SANDIA REPORT

SAND2005-7339

Review of the Independent Risk Assessment of the Proposed Cabrillo Liquefied Natural Gas Deepwater Port Project

**REVIEW OF THE INDEPENDENT RISK ASSESSMENT OF THE
PROPOSED CABRILLO LIQUEFIED NATURAL GAS
DEEPWATER PORT PROJECT**

Figure 4: Sandia calculation of pool fire hazards.

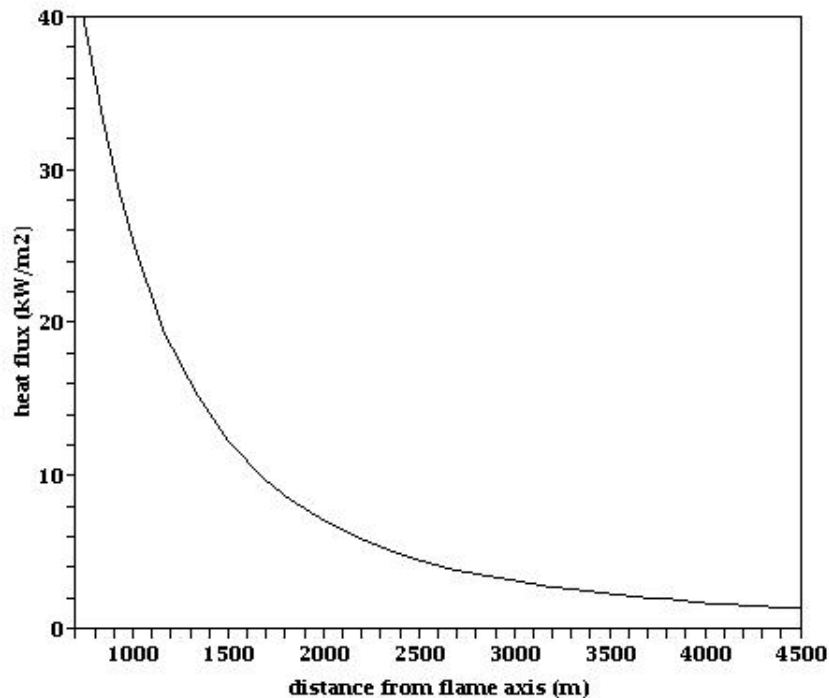
Sandia reviewed and assessed the ACE pool fire calculations by calculating heat flux as a function of distance as shown in Figure 4. The Moorhouse correlation was used for flame height and a surface emissive power of 220 kW/m², as well as a burn rate of 3 x 10⁻⁴ m/s, and a transmissivity of 0.8 were used. The Moorhouse correlation and view factors can be found in the SFPE Handbook of Fire Protection Engineering, 2nd edition¹³. Sandia pointed out that the 3rd edition has this equation misprinted where the leading factor should be 6.2 instead of 62. Both the Sandia and ACE results included this correction. The Sandia results are in close agreement with the results by ACE. The model used is appropriate given the absence of obstacles. The assumptions made are reasonable given the current knowledge of the required input parameters and should provide a conservative estimate of thermal hazard distances.

Figure 5: Sandia calculation of flash fire at 60 minutes after dispersion.

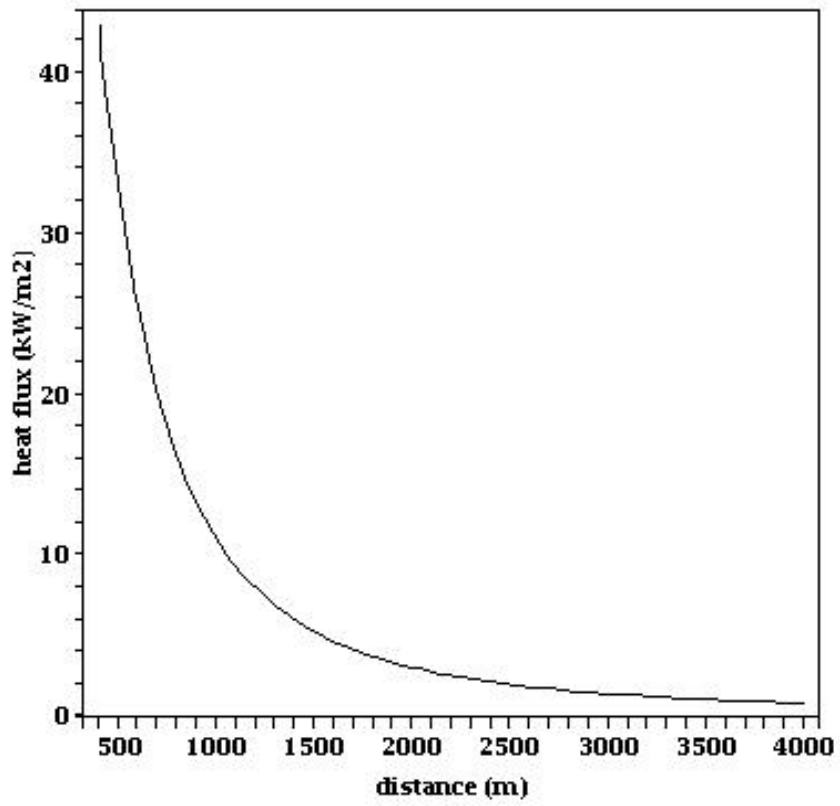
Sandia reviewed and assessed the flash fire results by calculating heat flux as a function of distance shown in Figure 5. The same input parameters were used as ACE except a surface emissive power of 220 kW/m² and an upward velocity of 0.2 m/s were used. This upward velocity will give a flame height to cloud height ratio of 10 which is what was found from the Coyote experiments on vapor cloud fires¹⁵. This approach results in a maximum flame width of 750 m. The results are in close agreement with the results by ACE. The model used and the assumptions made should provide a conservative estimate of the thermal hazard distances. The results are also conservative because of the transient nature and spatial variability of vapor cloud fires. Heat flux levels will not be maintained for durations required to cause injury at certain locations relative to the cloud. Thus, a global hazard zone as provided by ACE should be conservative.
